**Supplement
to the Montague Wind Power
Facility Application for
Site Certificate**

Prepared for
Oregon Department of Energy

March 2015

Figure U-3
Highway 19
Road Approaches
 1.5-MW Turbine Layout
 (Maximum Turbine Layout)
 Montague Wind Power Facility

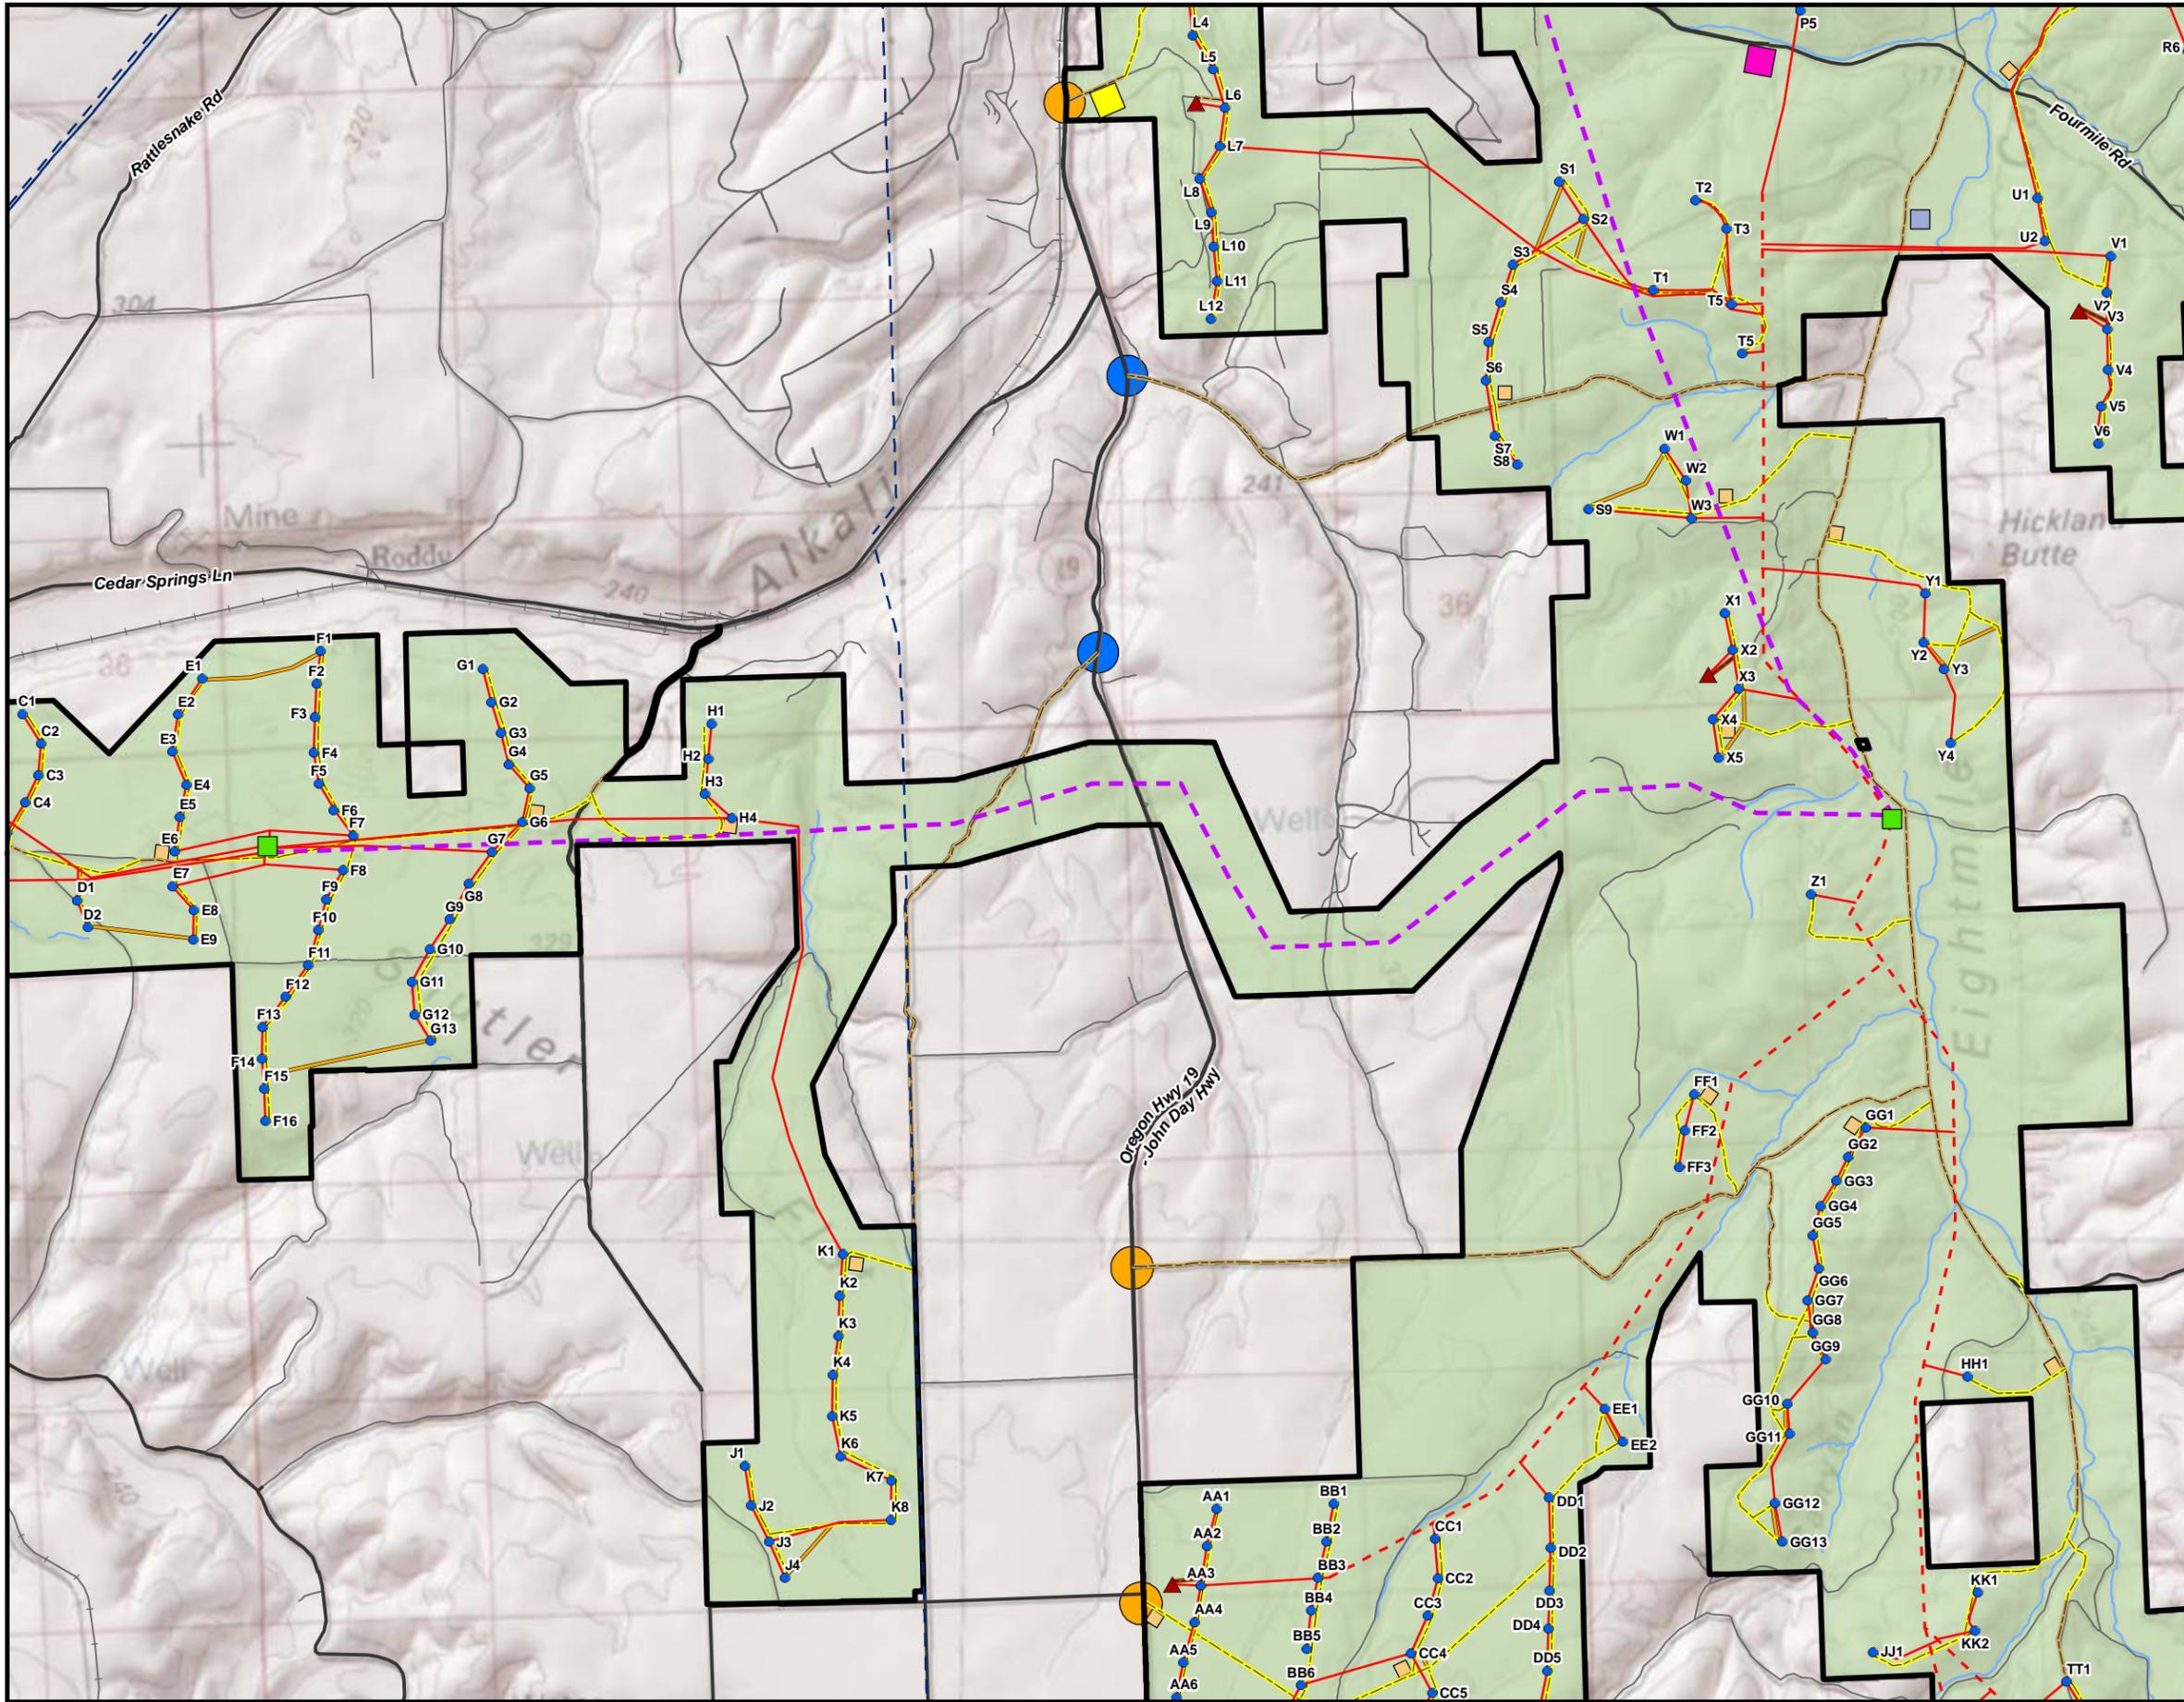
Modifications to State roads or highways may also be needed. For example, modifications may be needed at the intersection of Highway 19 with Tree Lane, Weatherford Lane, Montague Road, new access road south of Tree Lane, and on a private road to the proposed O&M building, as shown in revised Figure U-2 in Attachment U-1. Any modifications would be entirely within the County and State rights-of-way. IBR will contact the Oregon Department of Transportation (ODOT) to schedule a site visit to review approaches onto Highway 19 and will confirm the necessary permits. Permits needed for this project relevant to the approaches for Highway 19 are anticipated to be the same as those required for the nearby Pebble Springs and Leaning Juniper II projects:
